Keithley Instruments
28775 Aurora Road
Cleveland, Ohio 44139
1-800-833-9200
tek.com/keithley

Model 2450 Interactive SourceMeter Š Instrument, 2450-~~RP~~, 2450-RACK, 2450-NFP-RACK

VERSION 1.7.3 RELEASE

GENERAL Models affected:

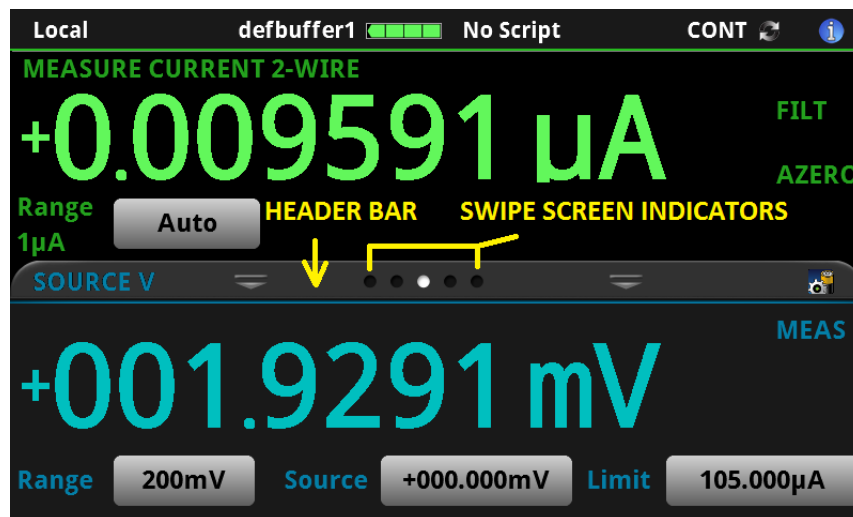
1. Screen Colors: All screen colors have been modified for better contrast and easier readability.
2. Pinch-to-Zoom Performance: Throughout the user interface, the “Pinch-to-zoom” touch screen motion has been improved and is more responsive.

3. Improve Swiping:
 - a. The swipe user interface gesturing has been dramatically improved and is more responsive.
 - b. Added Vertical Swiping in various screens in the GUI.

- e. Swipe Down on the Home screen will display larger readings.
4. Tabs and Buttons: Throughout the user interface multiple data display options have been made available through tabs (header bars) with swipe screen indicators to show how many options are available and which display tab is active.

Implement new Virtual Front Panel capability.

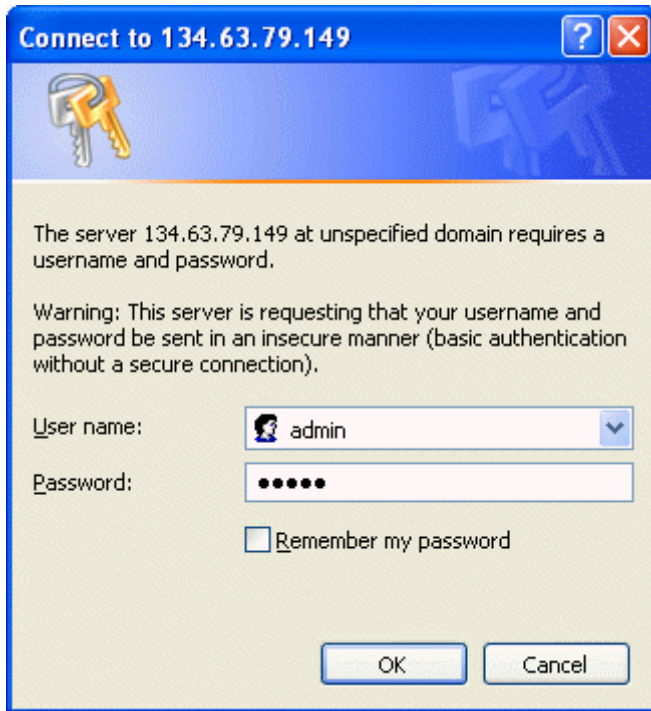
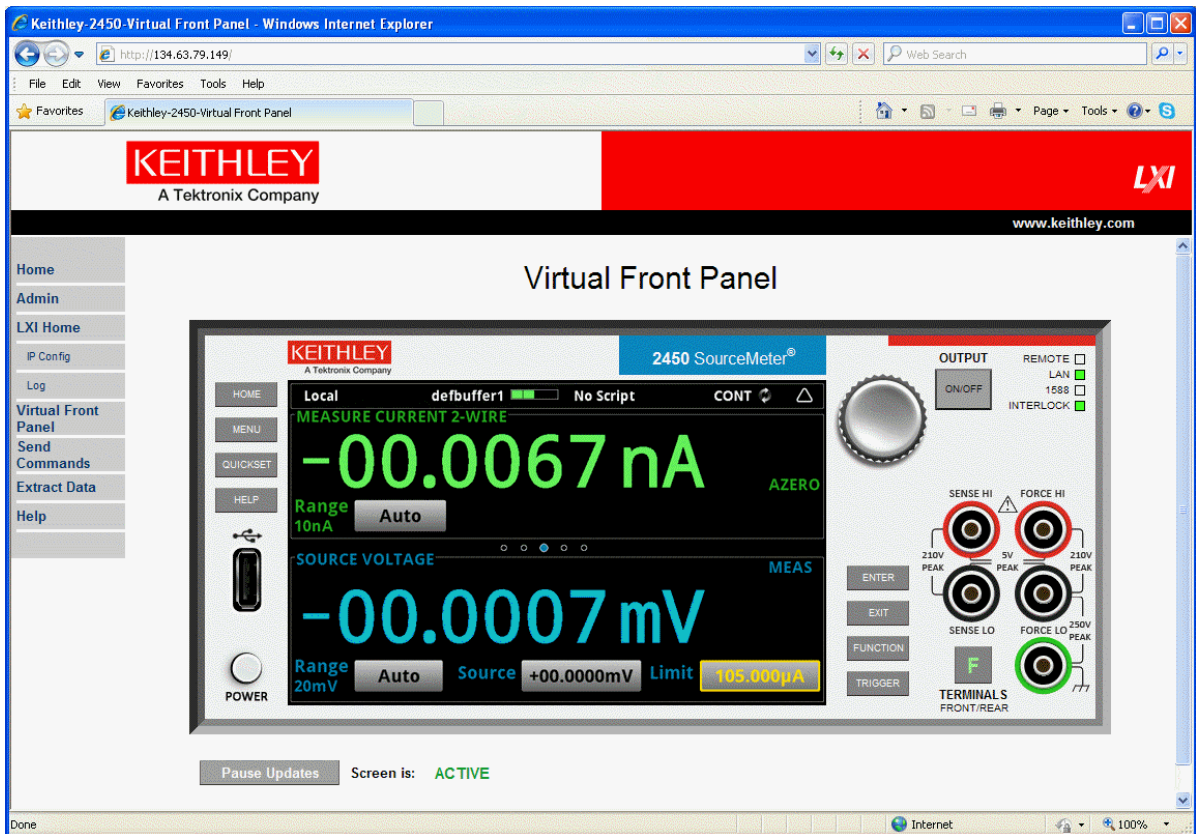
To access the new Virtual Front Panel, access the 2450 through Ethernet using your favorite Internet browser.

When asked for a Username and Password: enter the Username and Password for that particular 2450. The default Username is admin and the default Password is admin.

An example of the 2450 Virtual Front Panel is shown below. Users can use their mouse from a standard PC to control the instrument. Users can also use touch screens from most touch screen devices that can access the 2450 IP address.

The behavior of the *LANG? command on the 2450 has been changed as follows.

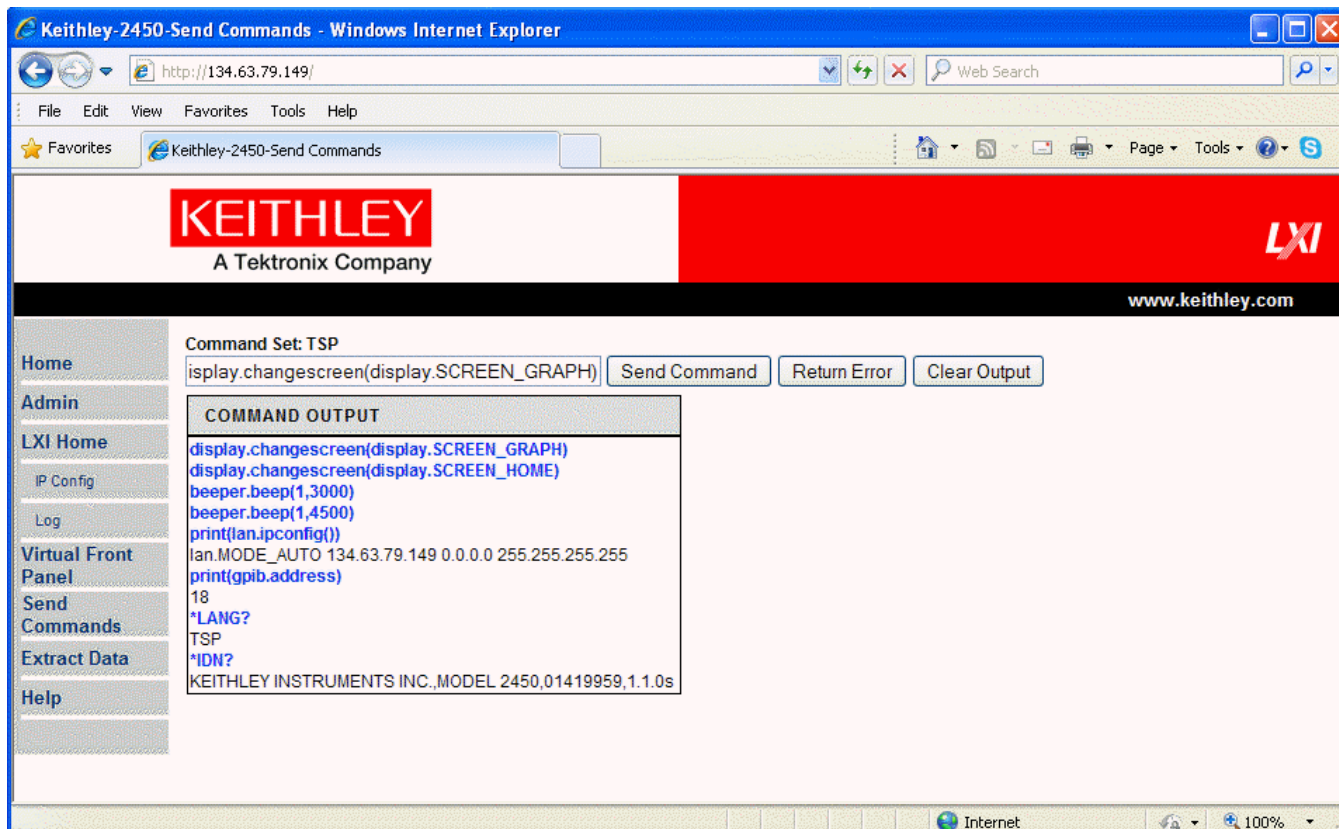
Sending the query *LANG? over a non-controlling interface will no longer change the interface control of the unit. For example, if the unit is under local control, then sending the *LANG? over Telnet, USB, or GPIB will leave the unit under local control. This was done in order for KickStart (or any other remote control software) to query connected/accessible instruments without resetting them or changing or disturbing the current trigger model.

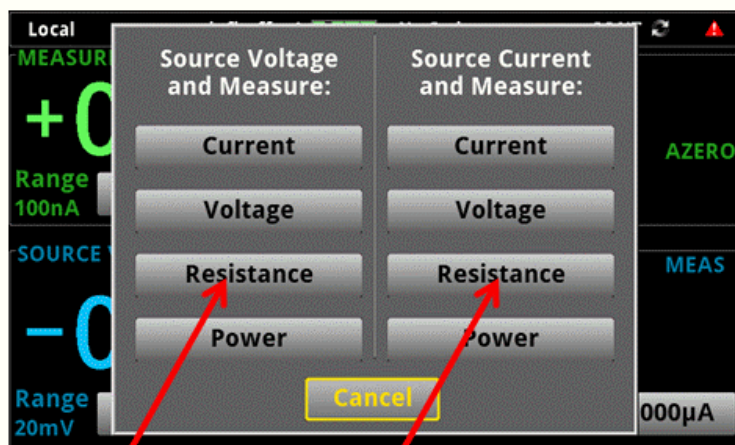
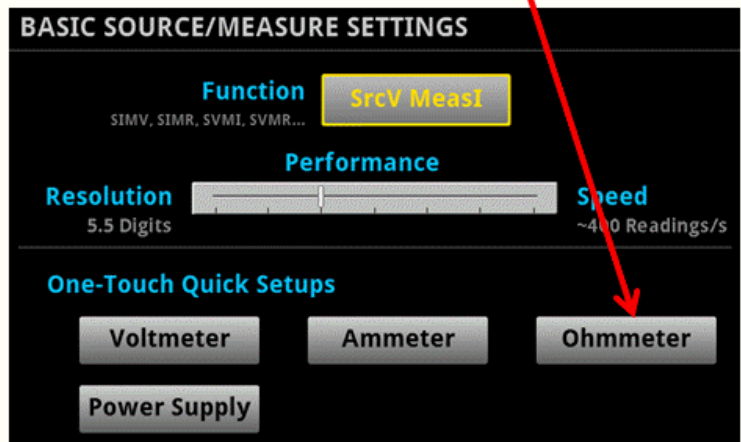
- g. New SCPI Command Usage:
 - i. "Manual Ohms" (see definition above)
 - SOURce:FUNC VOLTage
 - [SENSe[1]]:FUNC "CURREnt"
 - [SENSe[1]]:CURREnt:UNIT OHMOR
 - SOURce:FUNC CURREnt
 - [SENSe[1]]:FUNC "VOLTage"
 - [SENSe[1]]:VOLTage:UNIT OHM
 - ii. "Auto Ohms" (see definition above)
 - [SENSe[1]]:FUNC "RESistance"
- h. Front panel user interface setting of Manual vs. Auto Ohms measurements
<see the following figure for details>

Both exhibit "Manual" Ohms behavior (works just like Power by setting units to Ohms and going to SVMI or SIMV)

Exhibits "Auto" Ohms behavior
